ZAYO'S PRINEVILLE TO RENO PROJECT

CPUC MINOR PROJECT REFINEMENT FORM

Date Requested: 16 Oct 2024	Report No.: 11
Date Approved: 11/6/24	Approval Agency: Caltrans, in addition to CPUC
Property Owner(s): Caltrans (State Route 395 ROW)	Location/Milepost: PM M-0.45 to L-136.55 (N to S)
Land Use/Vegetative Cover: Ruderal (maintained highway shoulder near edge of pavement)	Sensitive Resources: Waterways at culverts to be avoided by boring underneath culverts. Rare plant populations being avoided by change in running line. Cultural resources present, being avoided.(See project webmap.)

The proposed change is a shift of the fiber optic running line from previously submitted engineering drawings. The change entails bringing the running line closer to the highway edge of pavement to avoid construction on slope faces and avoid tree driplines in accordance with the approved Caltrans Encroachment Permit. A portion of the change is being made to avoid a rare plant population.

SHEET NO.: 22 OF 105

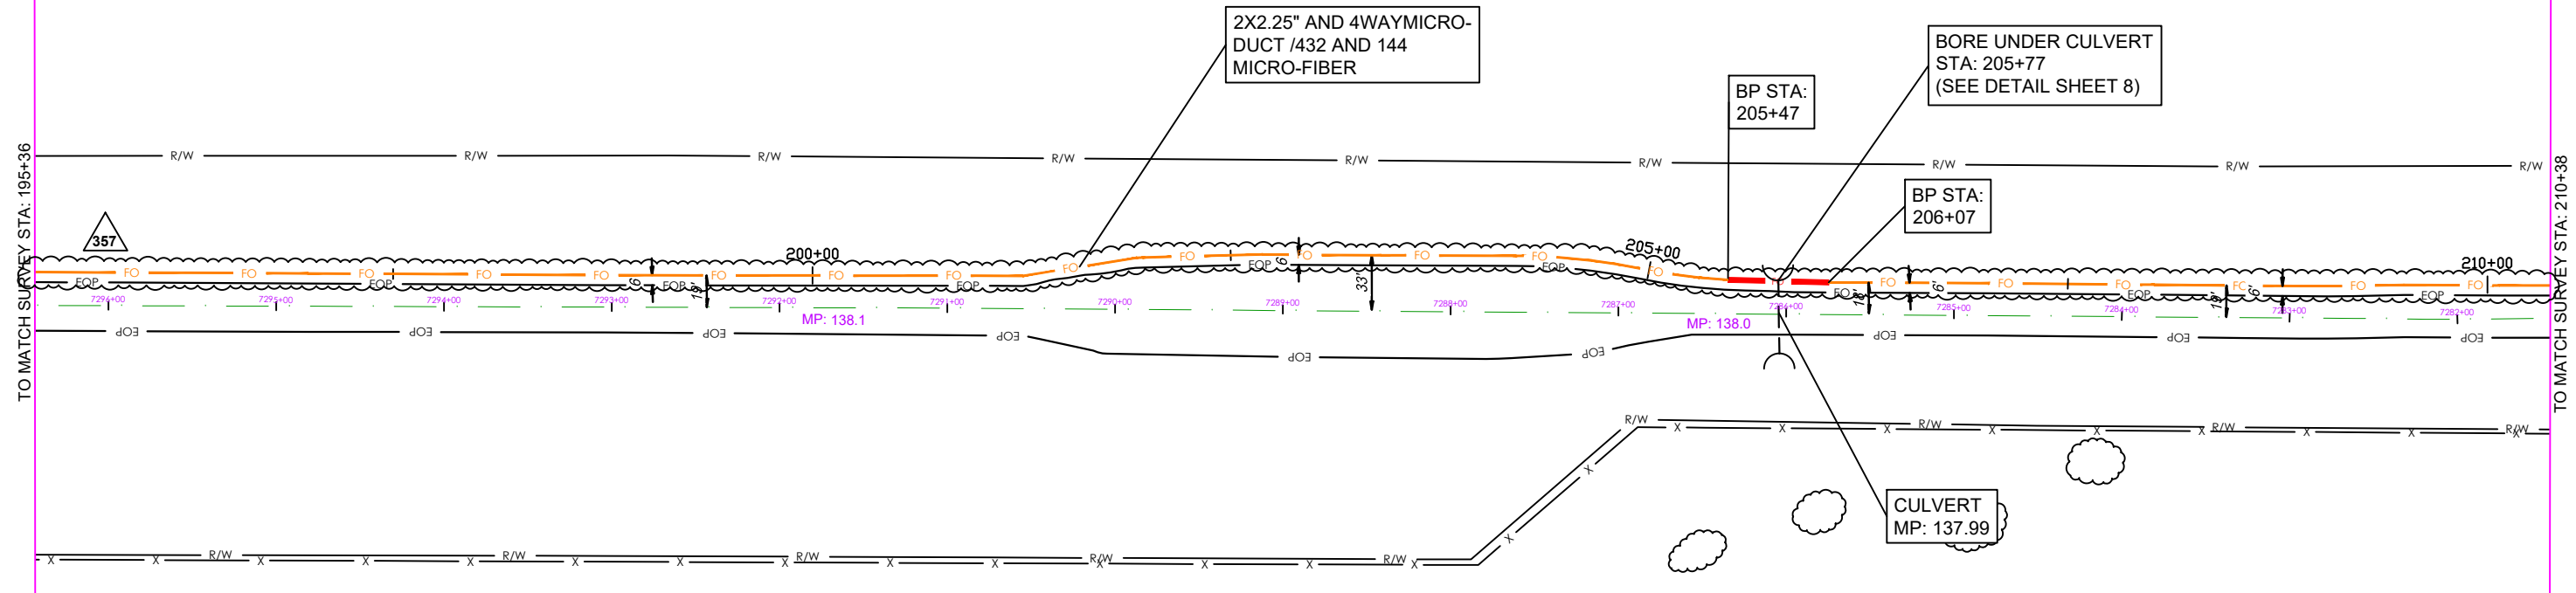
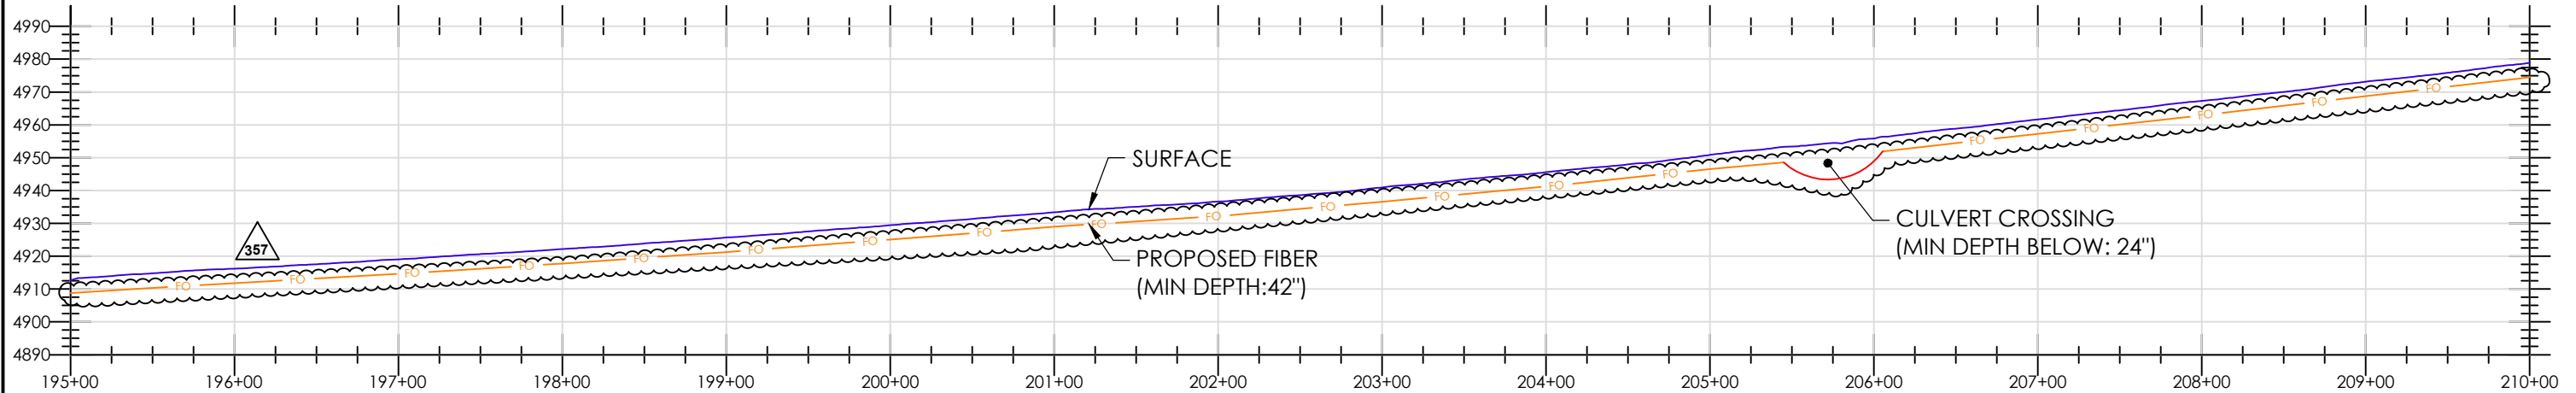
RFI NO. 0356: MOVE RUNNING LINE IN TO 6' OFFSET FROM EOP AVOIDING RARE PLANTS STA 199+25 TO STA 220+00 10/04/2024

SHEET NO.: 23 OF 105

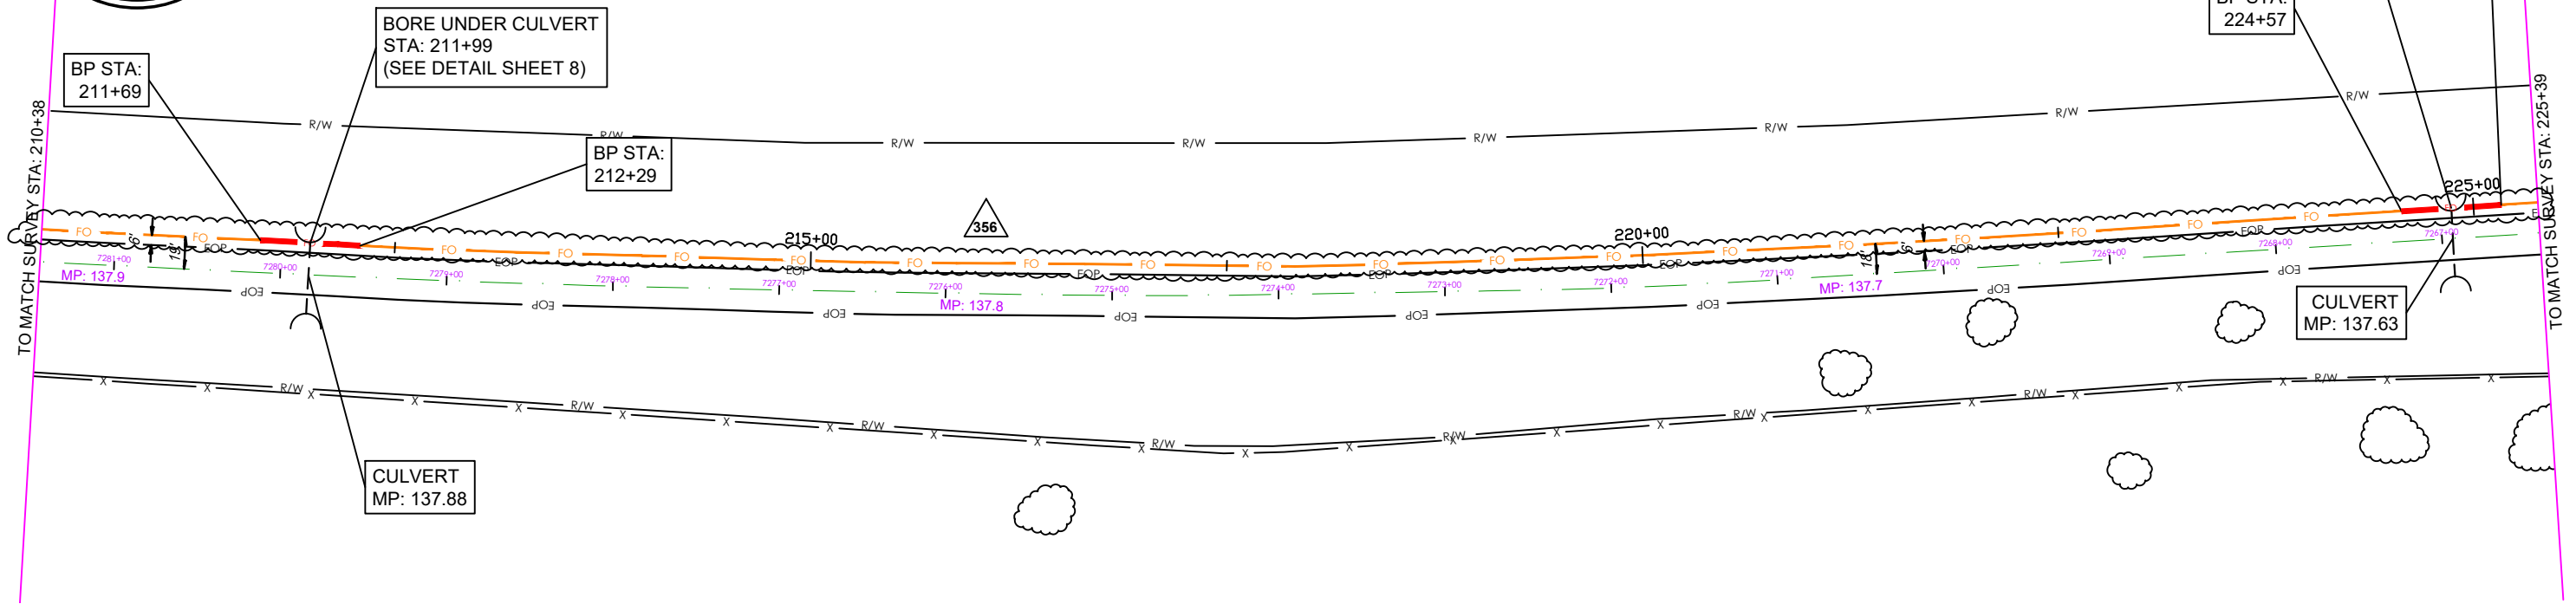
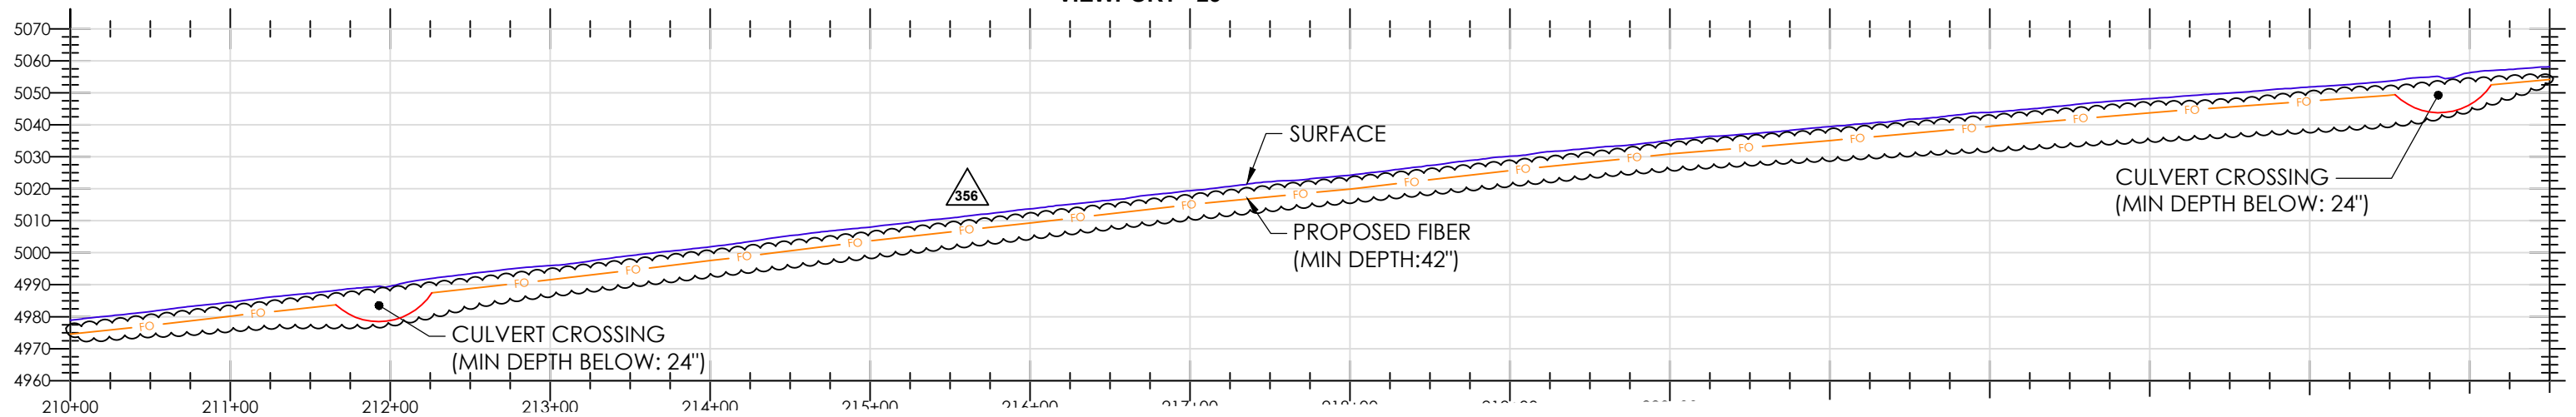
RFI NO. 0358: MOVE RUNNING LINE TO 6' OFFSET FROM EOP AVOIDING TREE DRIPLINES AND BOULDERS STA 232+13 TO STA 284+00	10/04/2024
RFI NO. 0357: MOVE RUNNING LINE IN TO 6' OFFSET FROM EOP AVOIDING RARE PLANTS STA 205+50 TO STA 227+60	10/04/2024

SHEET NO.: 25 OF 105

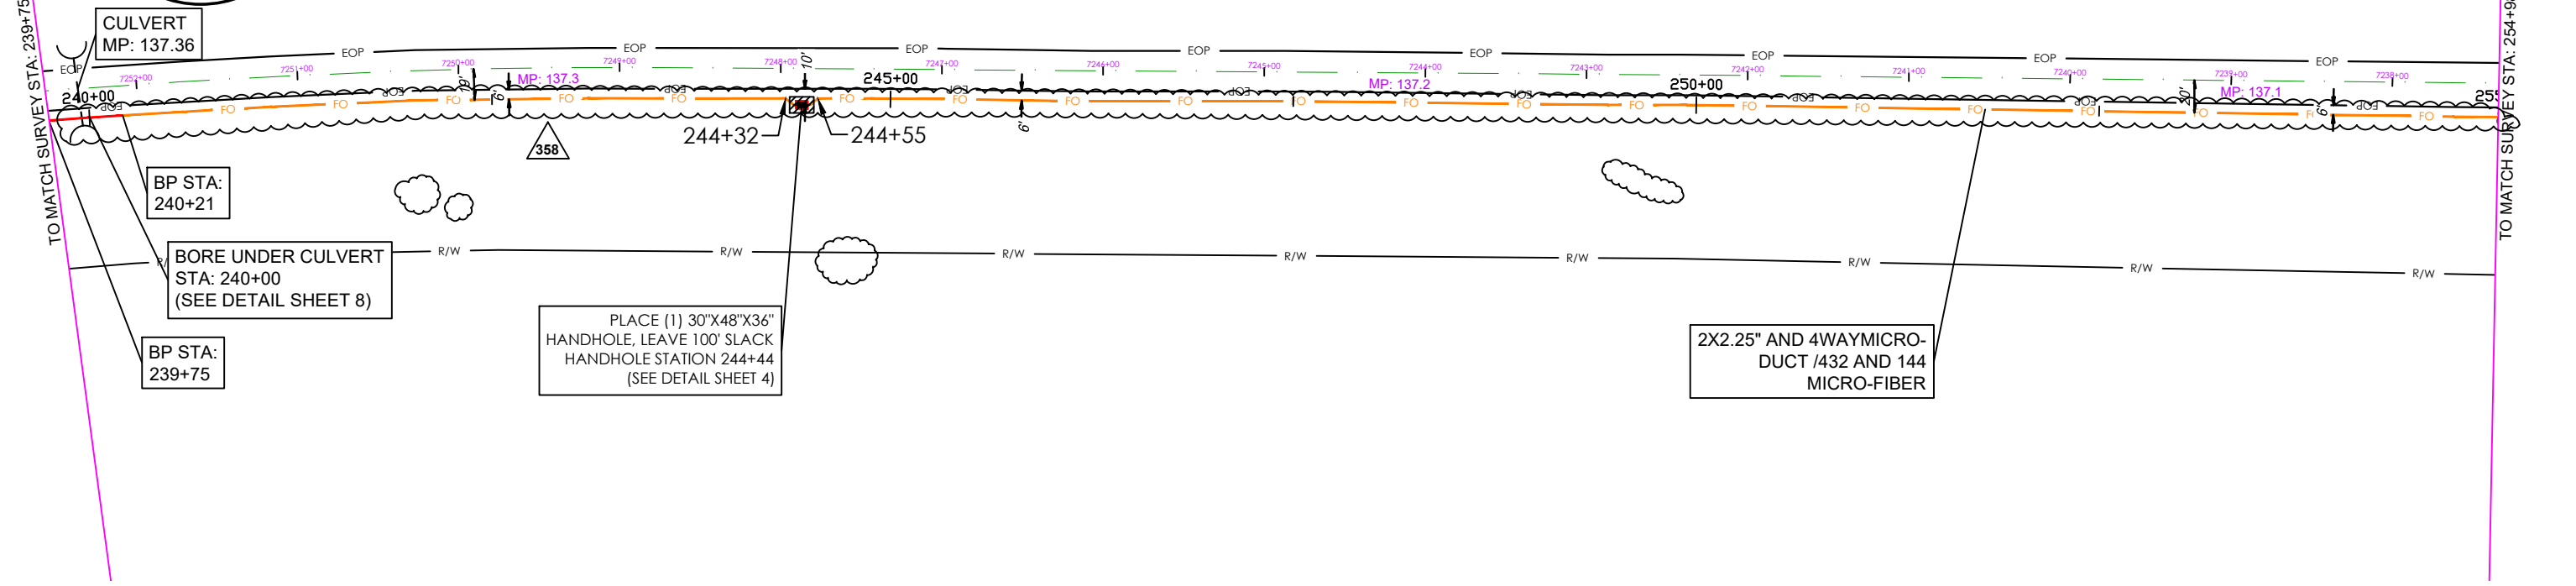
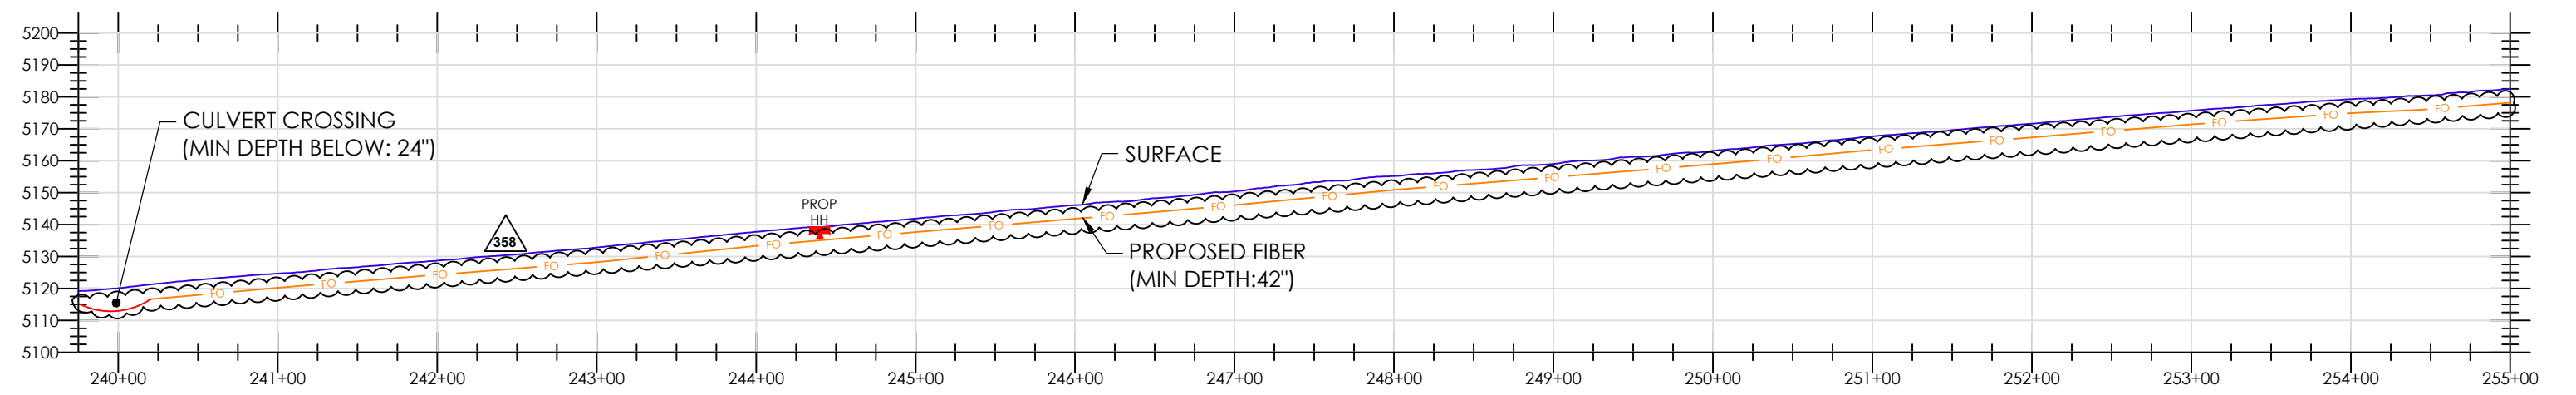
RFI NO. 0358: MOVE RUNNING LINE TO 6' OFFSET FROM EOP AVOIDING TREE DRIPLINES AND BOULDERS STA 232+13 TO STA 284+00
10/04/2024

SHEET NO.: **26 OF 105**

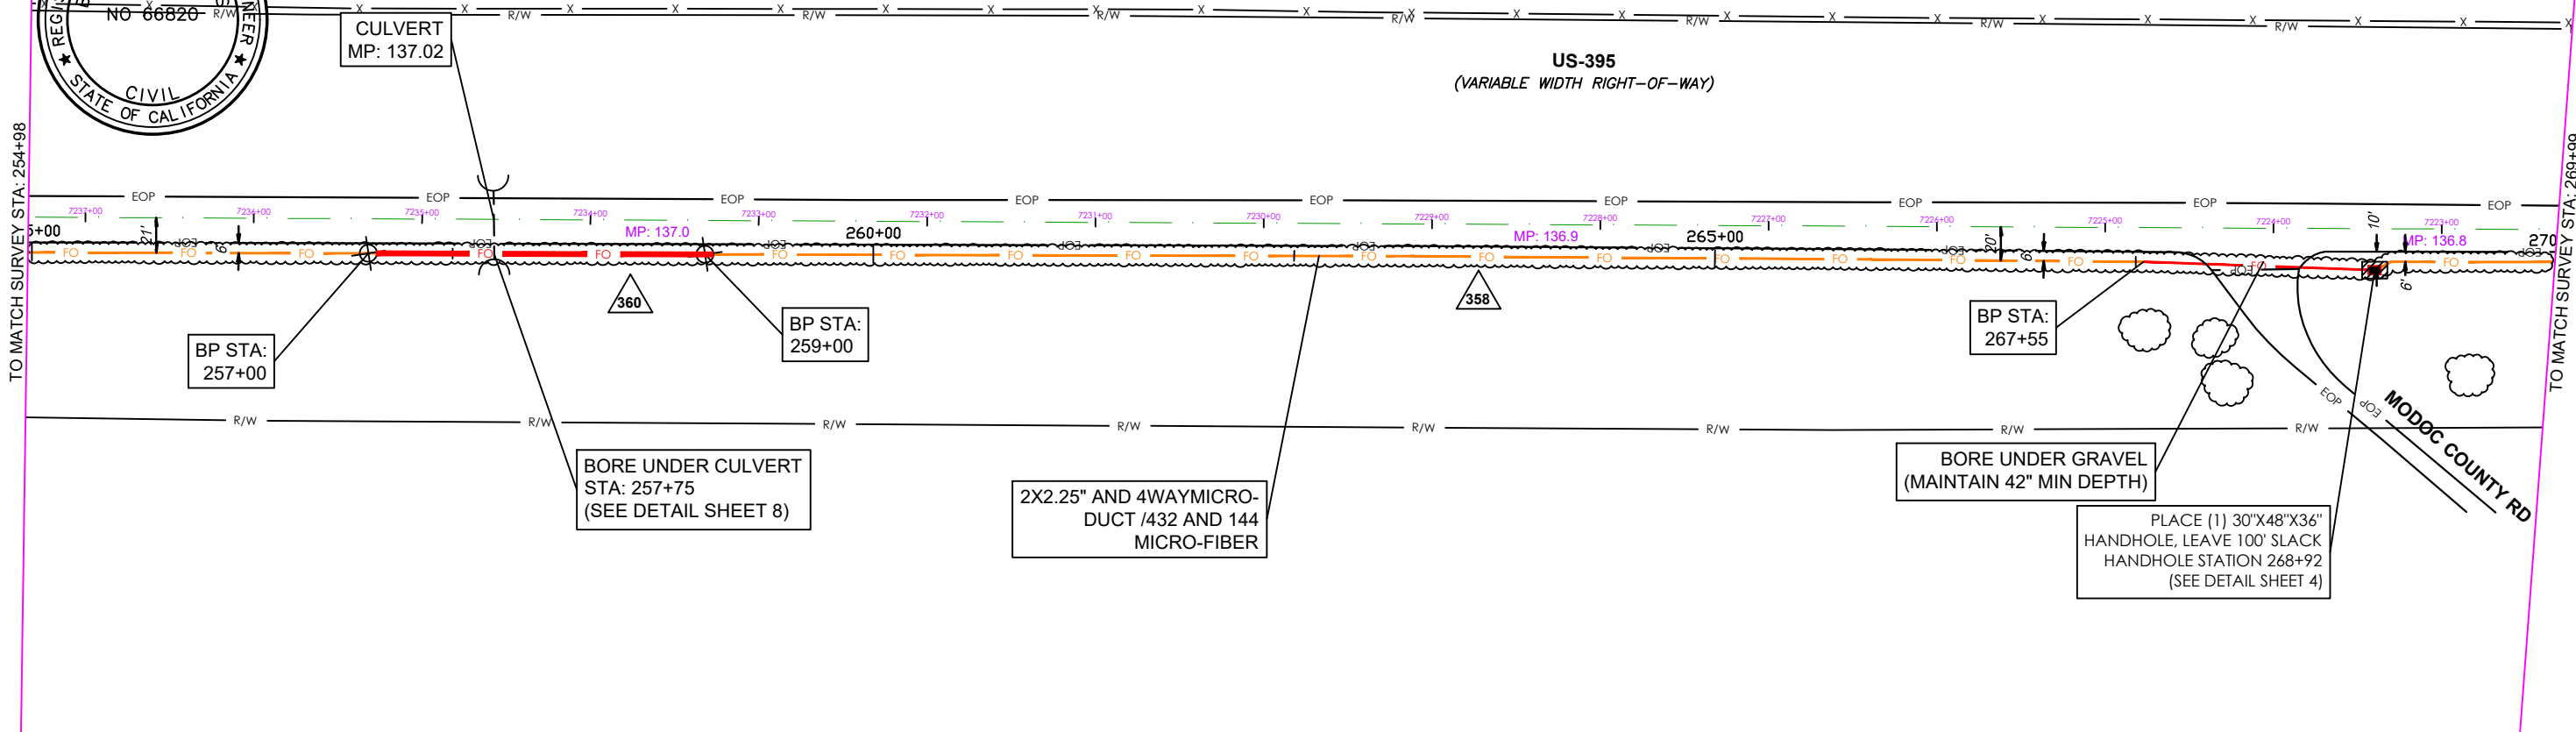
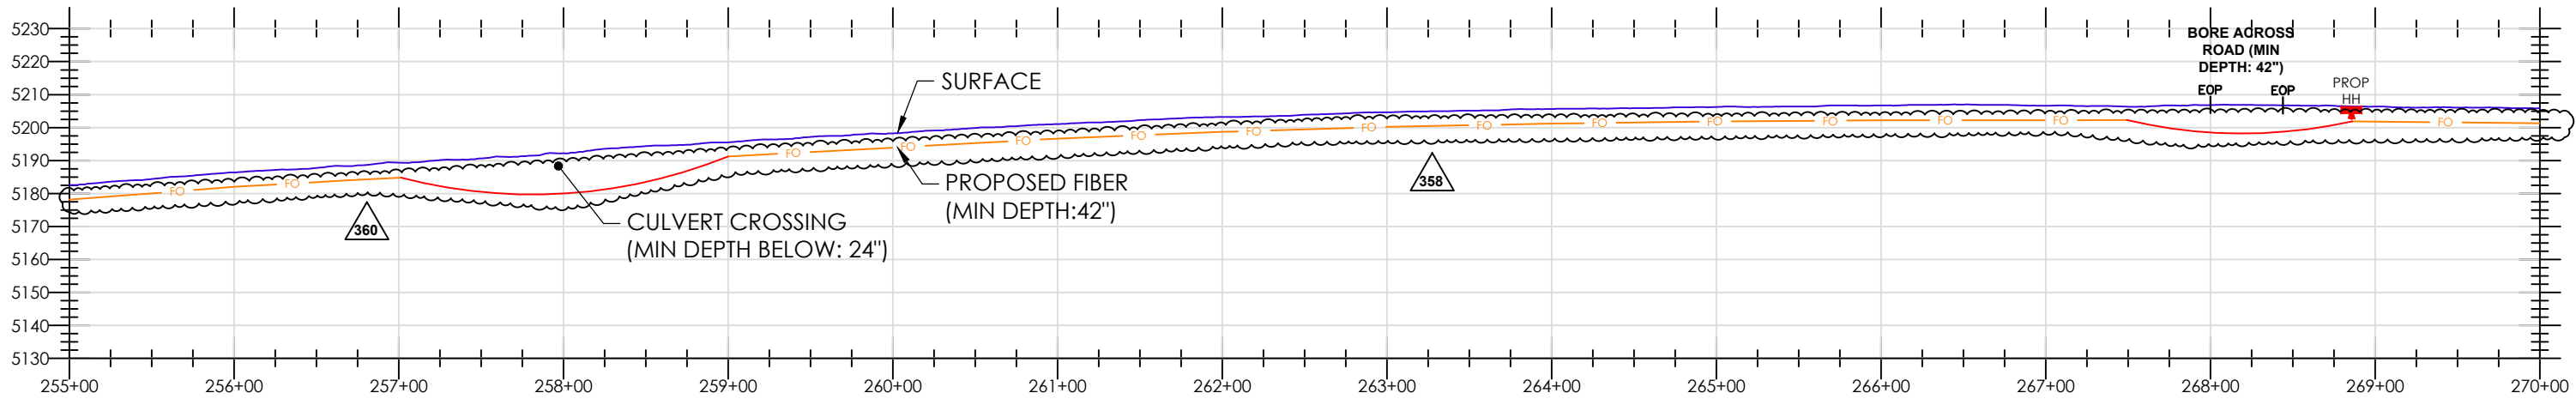
RFI NO. 0358: MOVE RUNNING LINE TO 6' OFFSET FROM EOP AVOIDING TREE DRILINES AND BOULDERS STA 232+13 TO STA 284+00	10/04/2024	RFI NO. 0360: BORE UNDER CULVERT STA 257+00 TO STA 259+00	10/04/2024
--	------------	---	------------
